CITY OF PORT WENTWORTH

FEBRUARY 6, 2020

11. UNFINISHED BUSINESS
12. NEW BUSINESS
    - A. Site Plan Review Application (Specific) 1500 Crossgate Road Dec 2019
      - ➢Public Hearing

B. Site Plan Review (Specific) Newport Cove Apartments 7-0976-02-021

SITE LAYOUT - SHEET 1

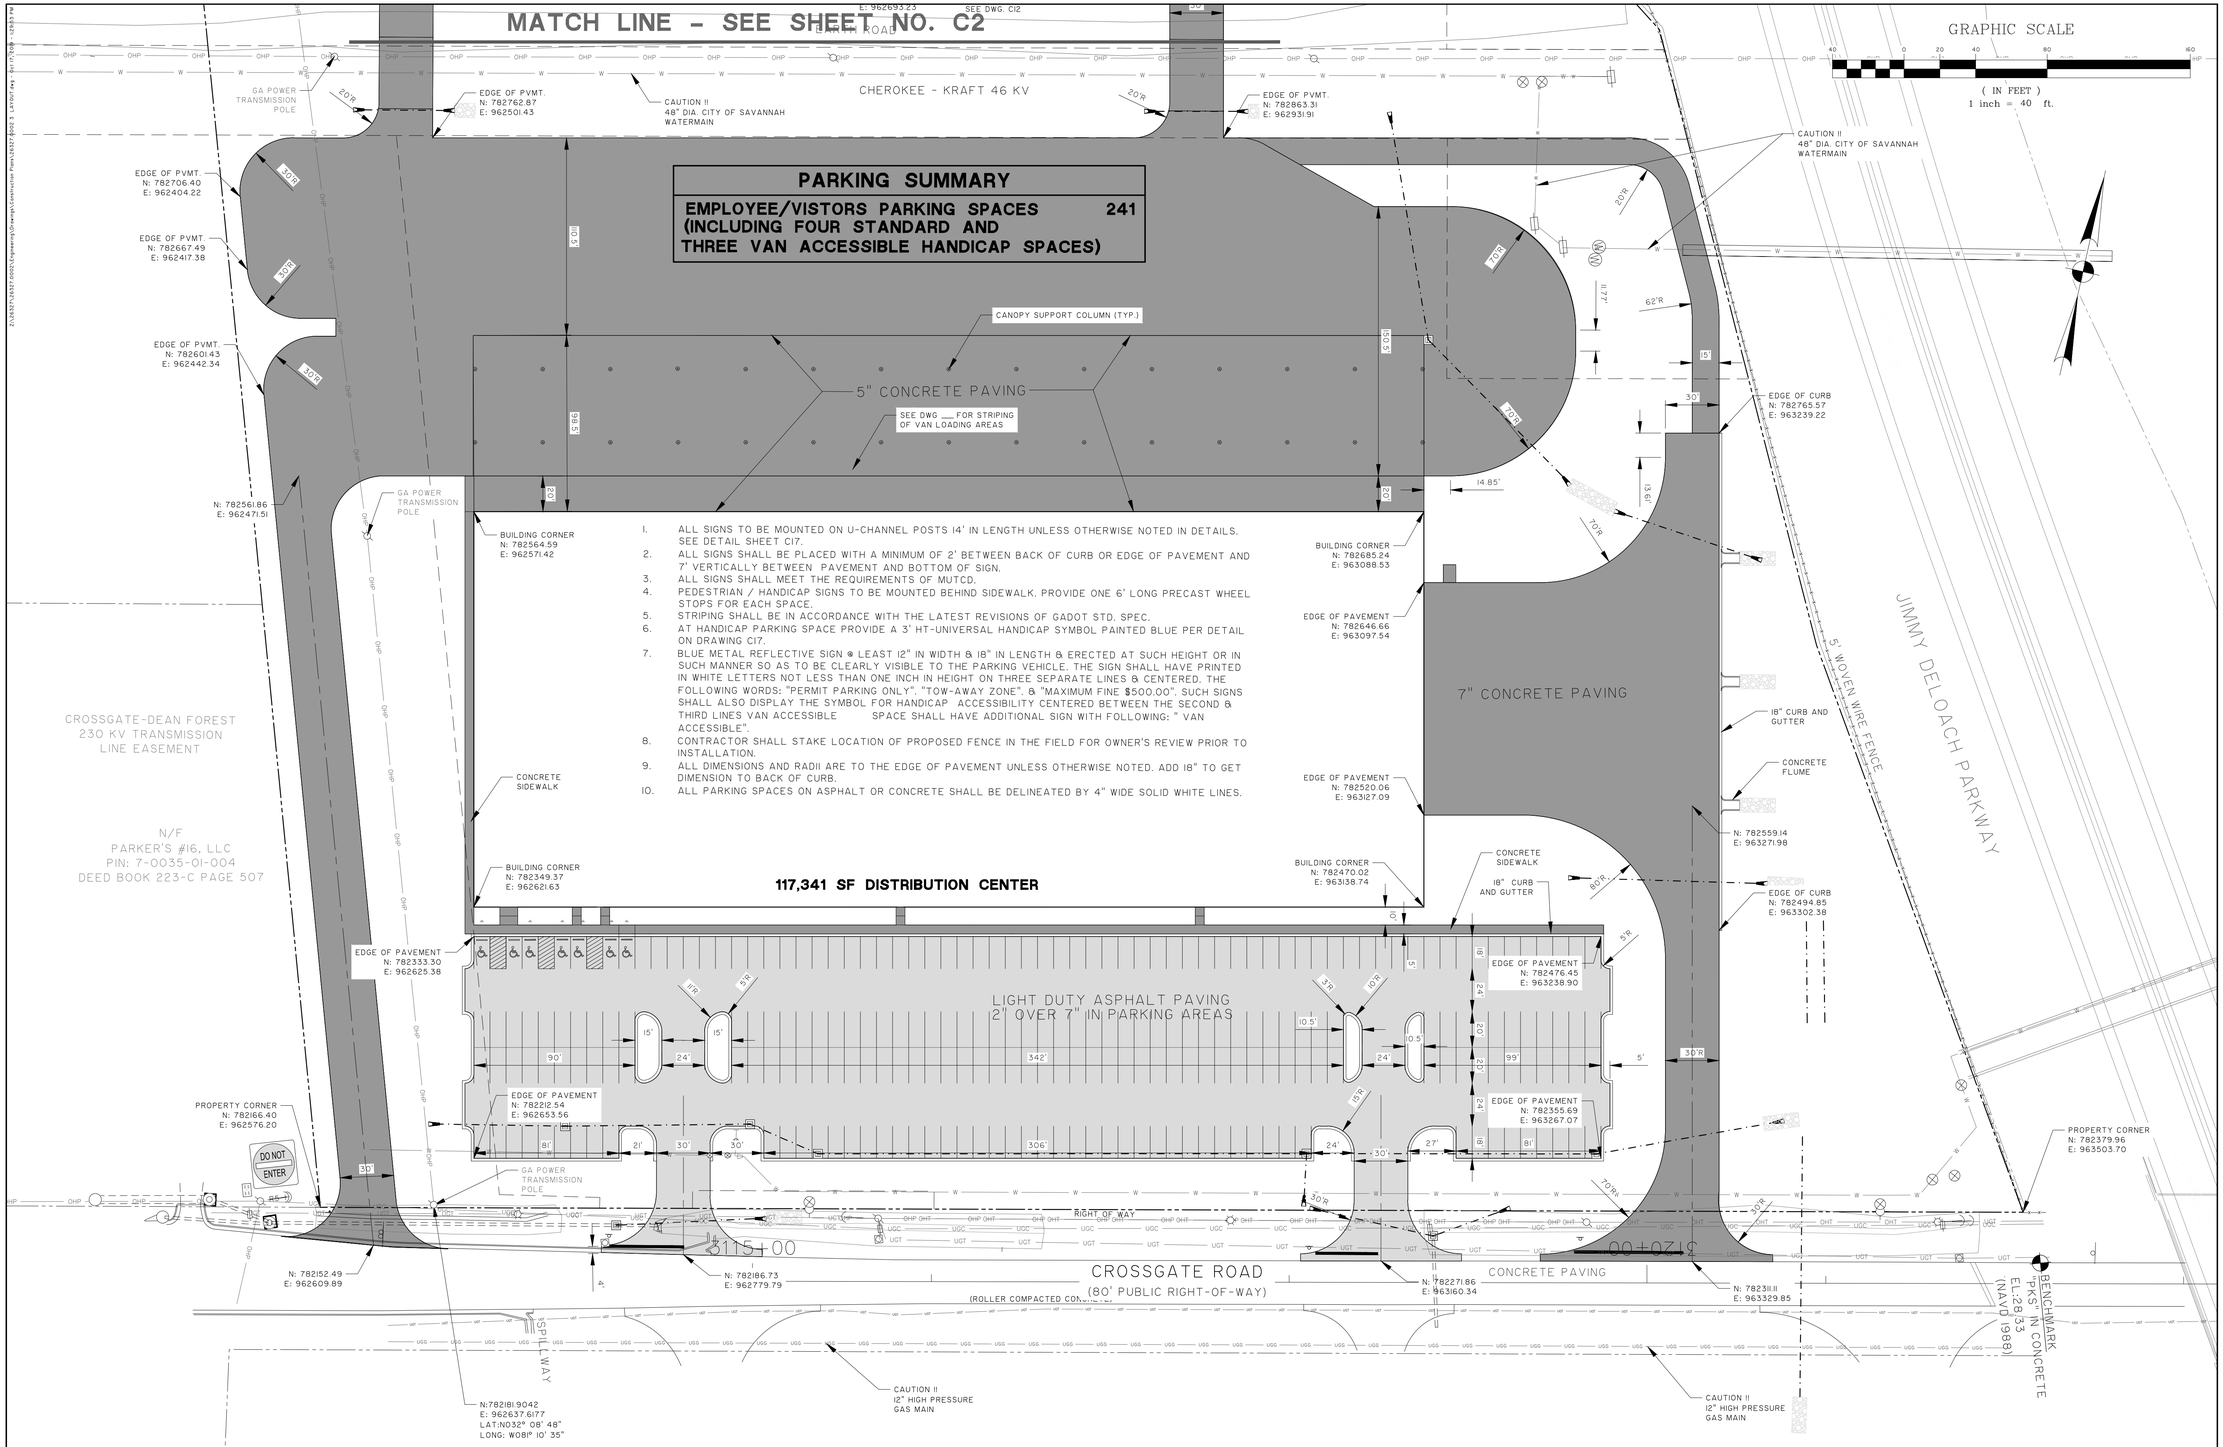
1. The automobile parking area in front of the building shows 2 rows of parking that are 18 feet deep and two rows that are 20 feet deep. The City requirement is 20 feet deep. Please adjust the site plan as necessary to achieve the depth of 20 feet.
Response: We have modified the spaces adjacent to 18" curb and gutter to be 19' long' to edge of asphalt providing a total of 20' space. Revised Drawing C1 is attached.

SHEET: 4

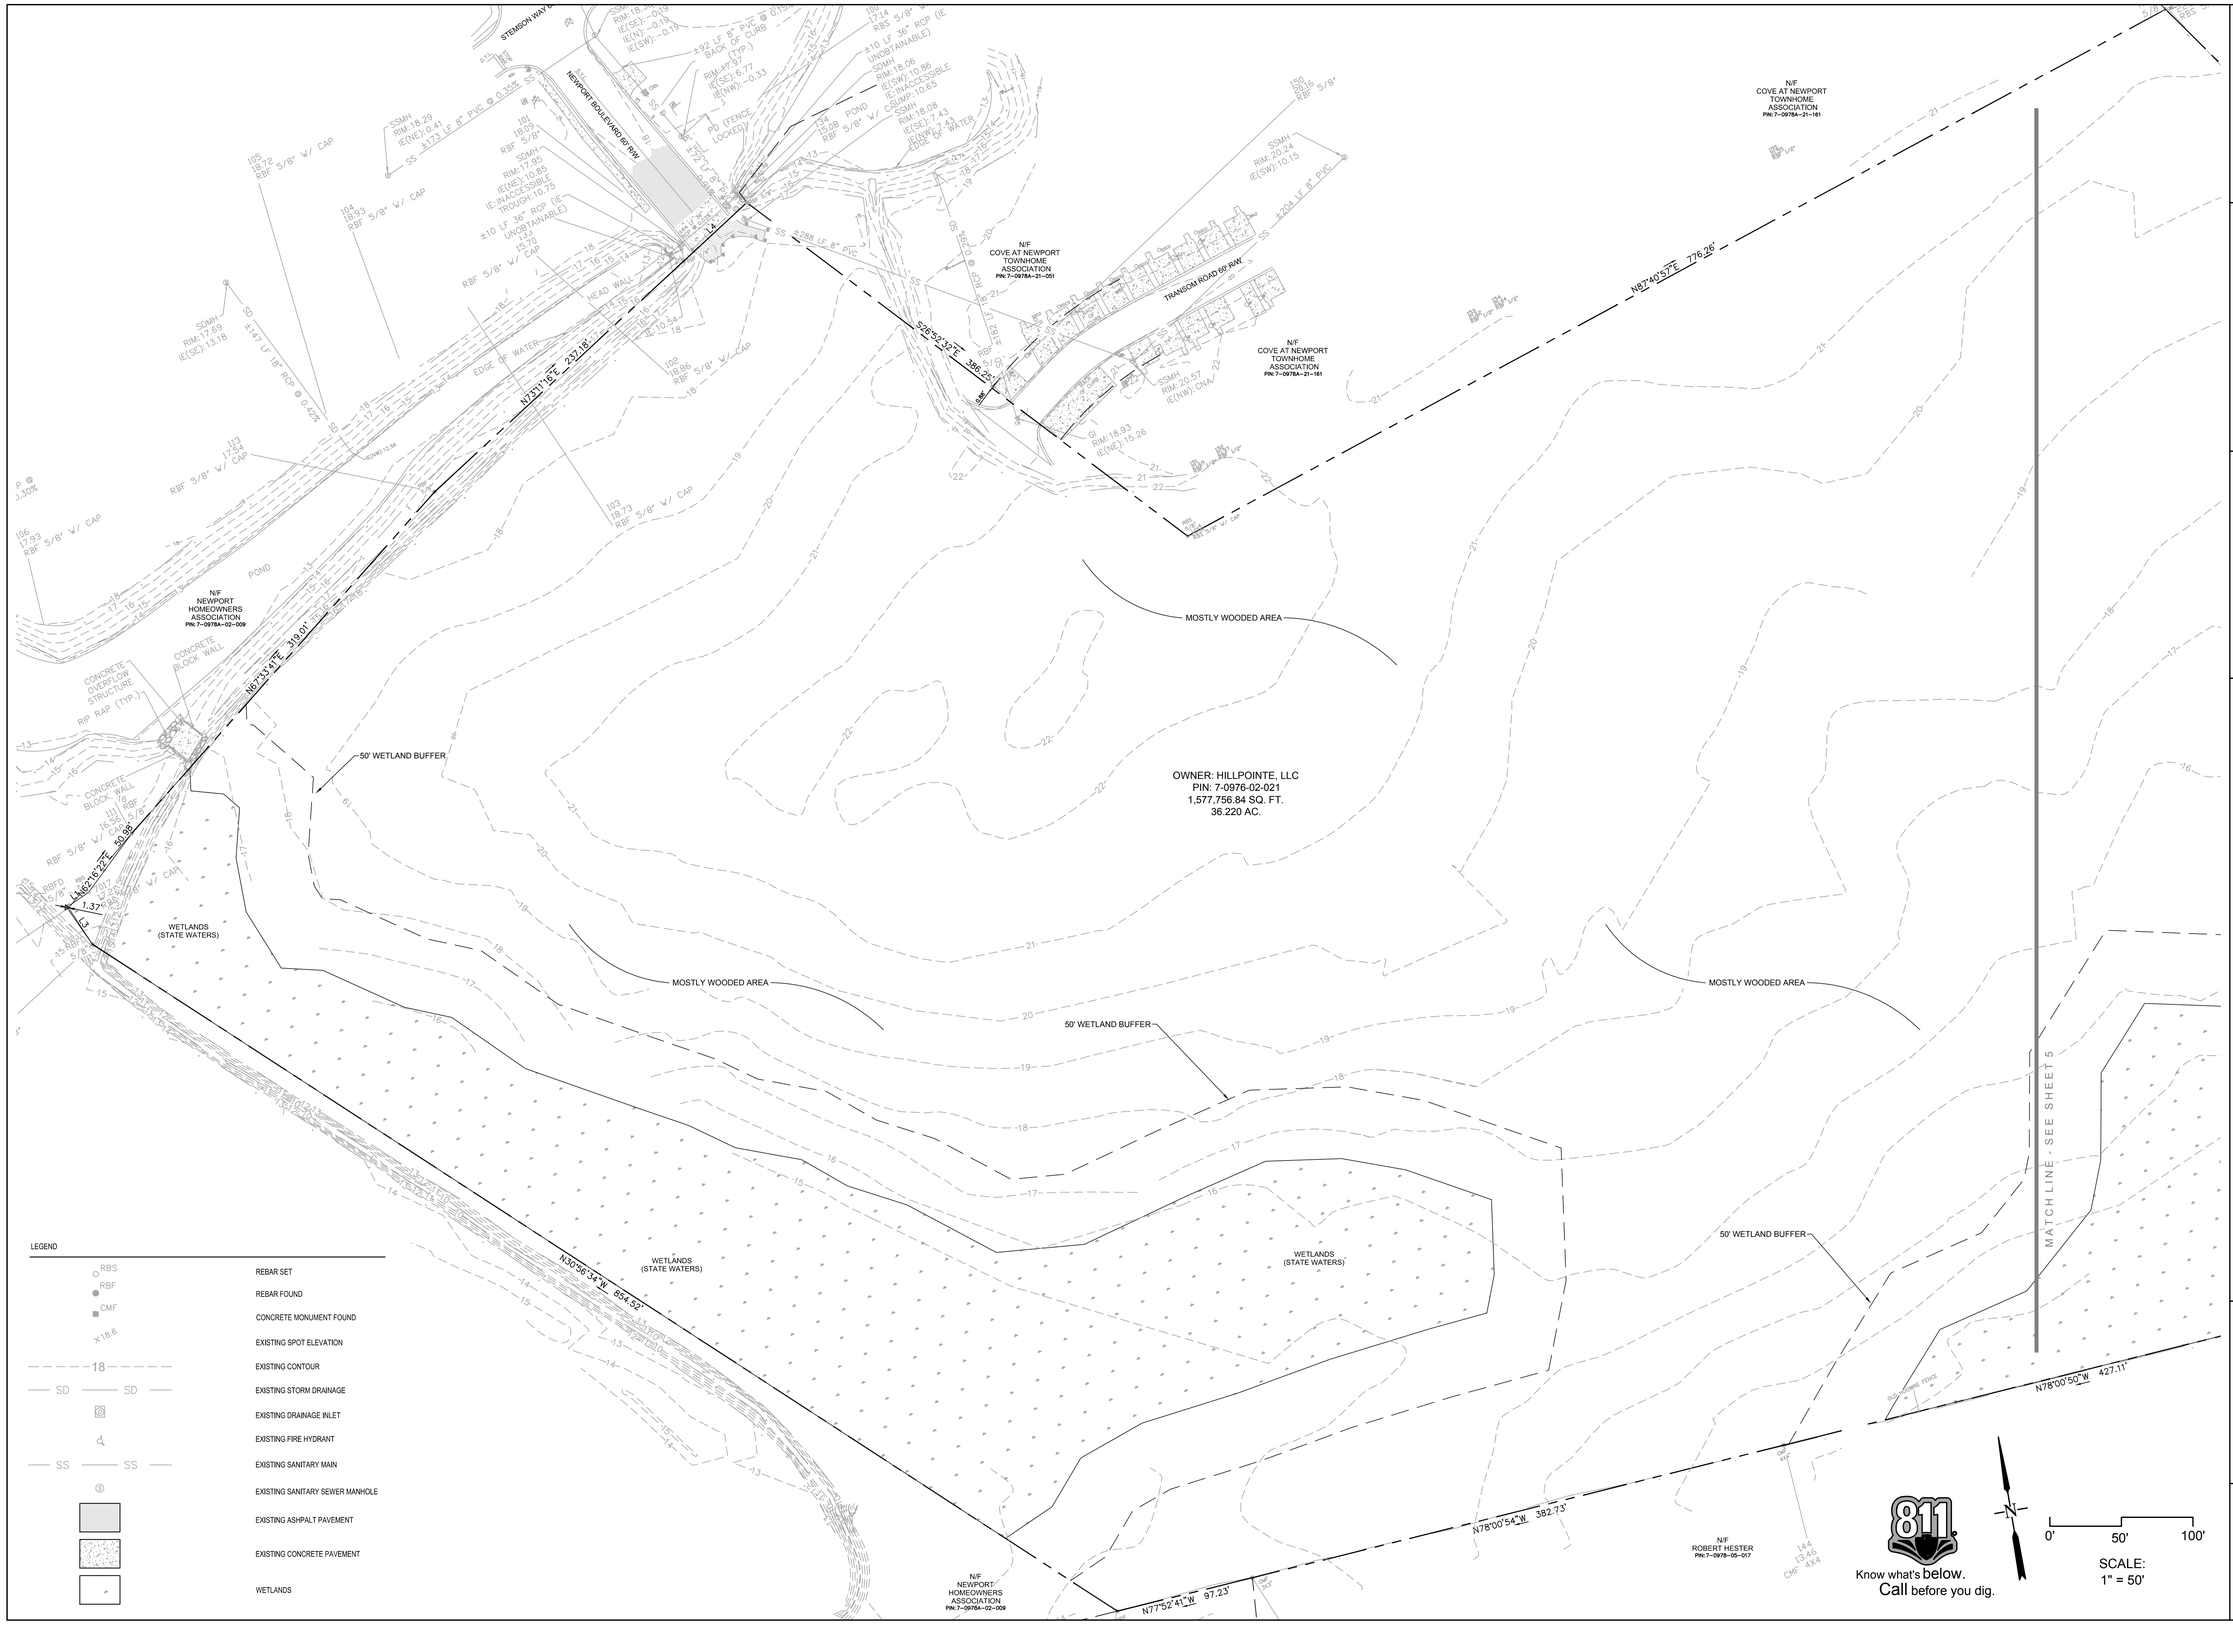
1. There is a discrepancy for the number of proposed buildings and units on Sheet 2 in the General Notes Section Item #1.
2. The site acreage listed on Sheet 2 does not match the site acreage listed on the sheet 4. Please confirm which area is accurate and update the plans, coverage percentages, and unit densities as needed.

SHEET: 7

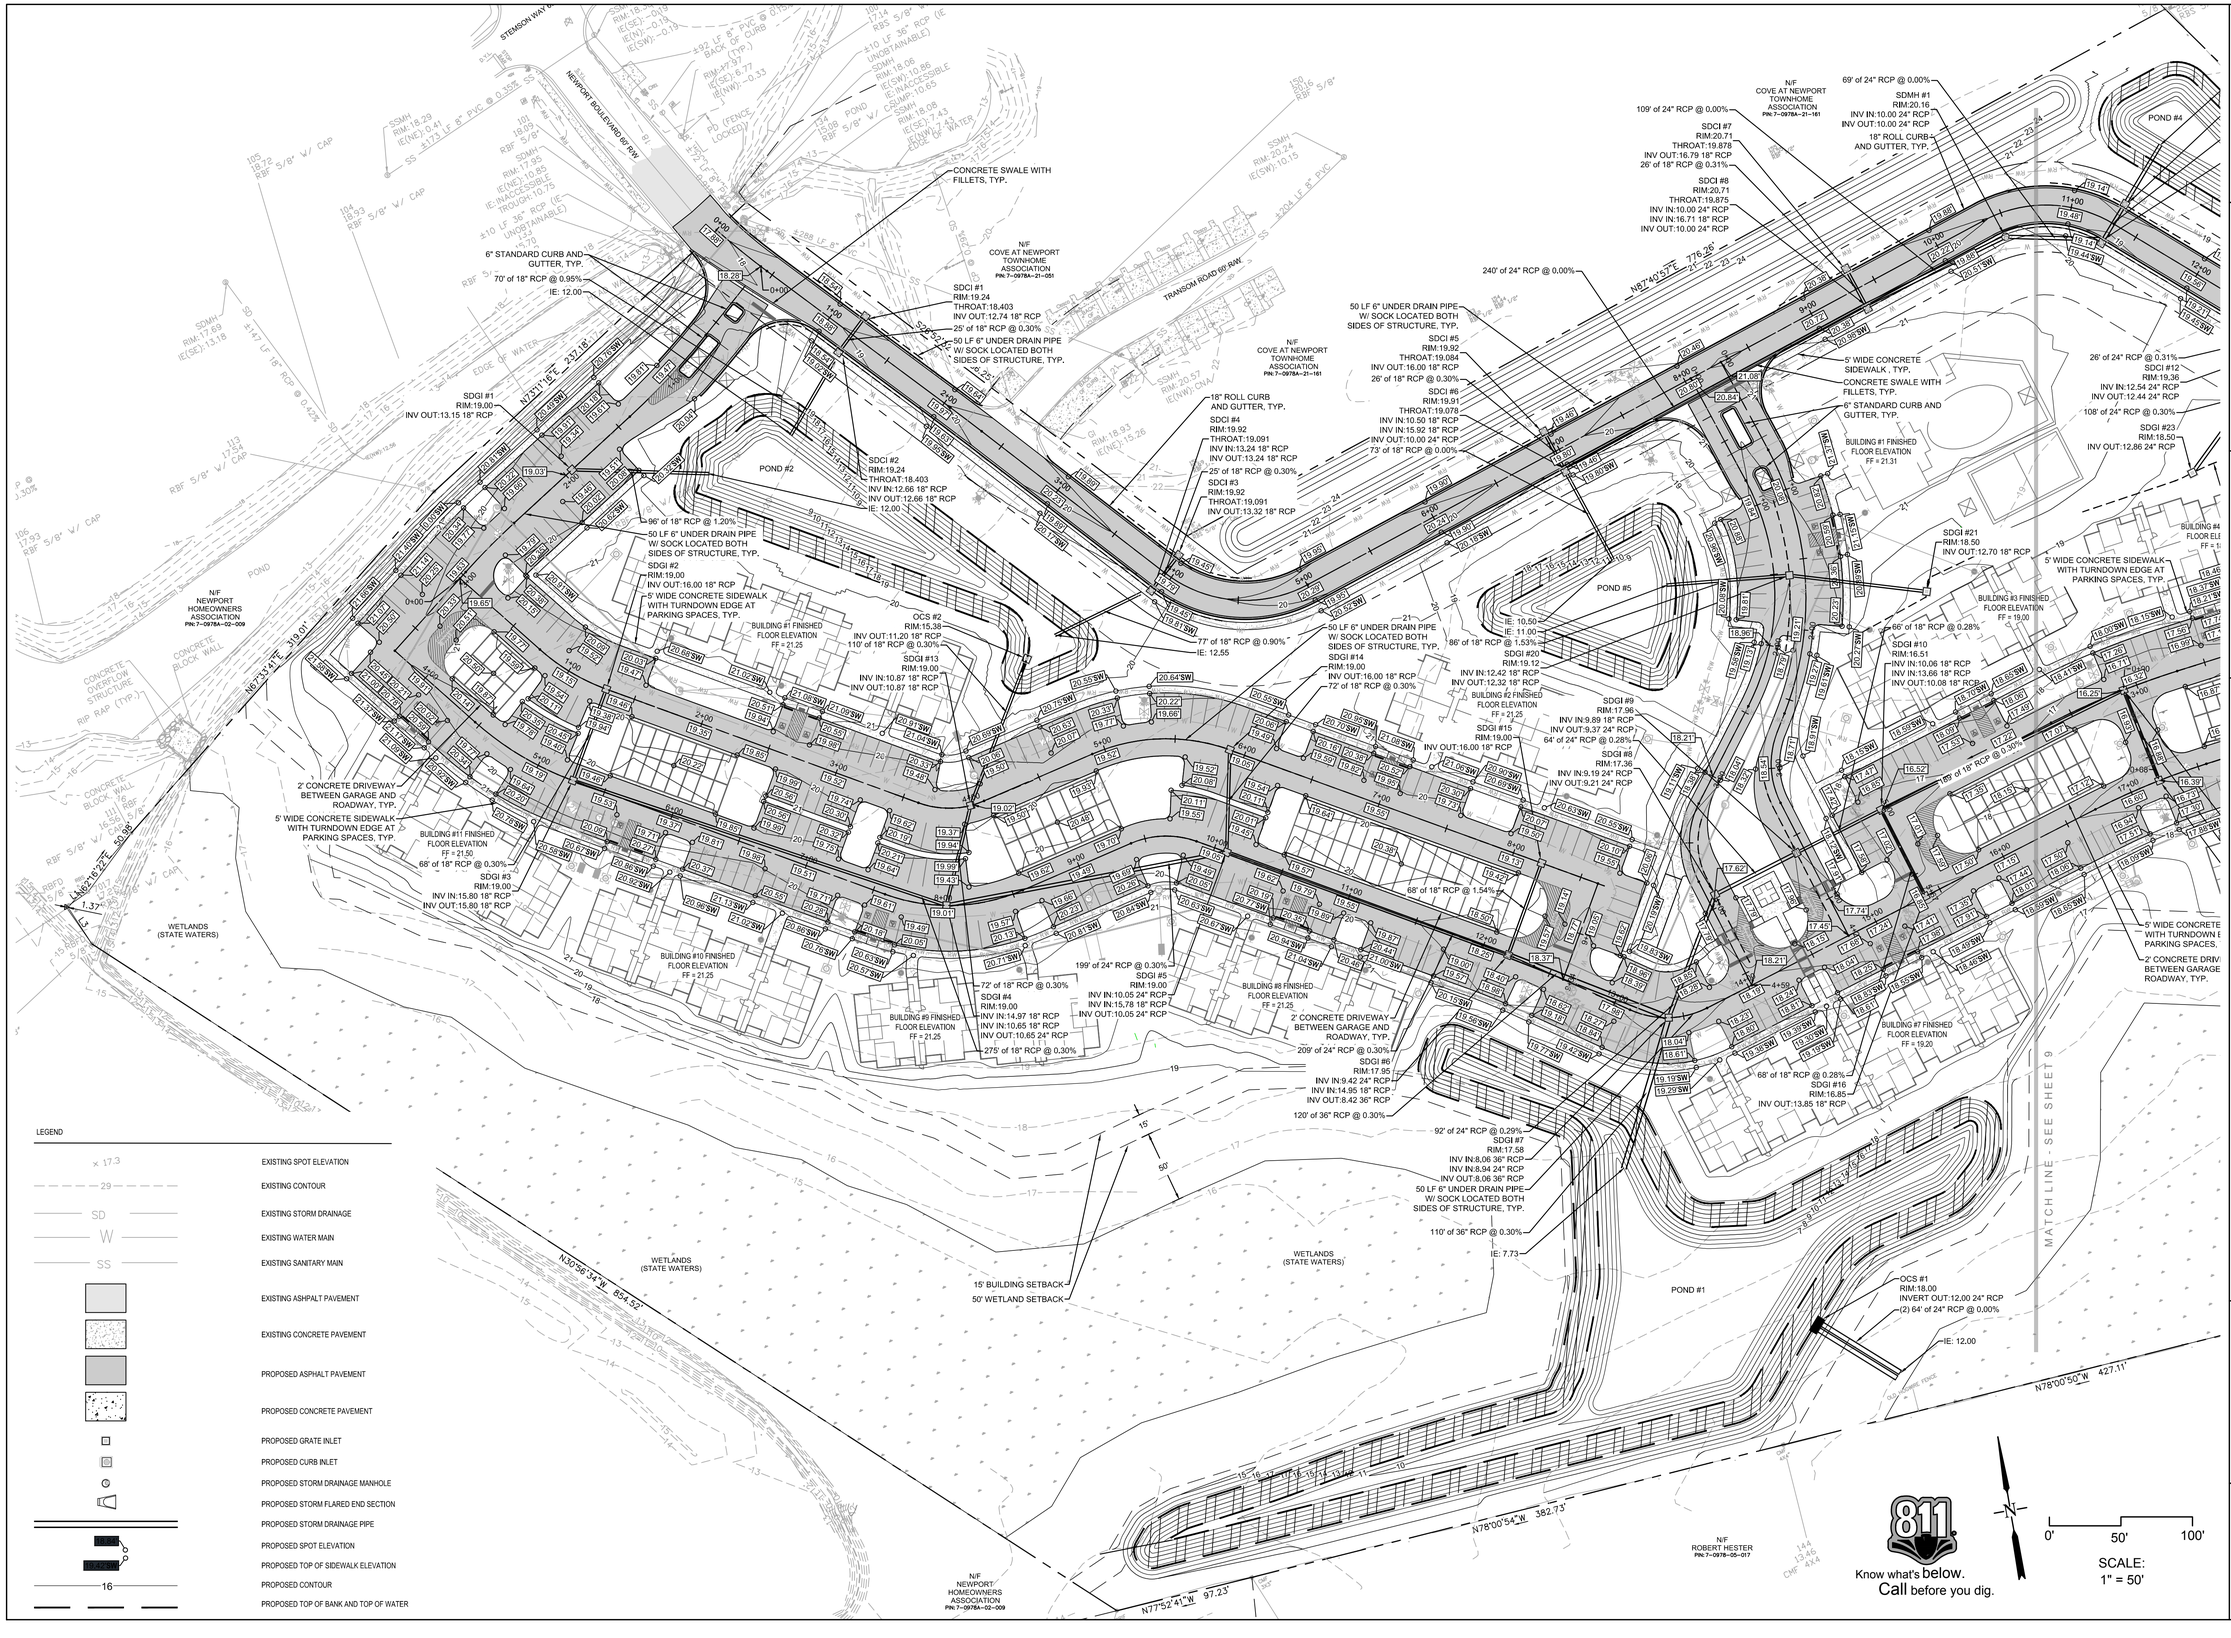
8. The signs near the car wash station on Sheet 7 should to be identified.
9. Please identify and label what the extra drive lane, that terminates into the Fire Lane on the middle entrance, will be used for and any necessary pavement hatching.
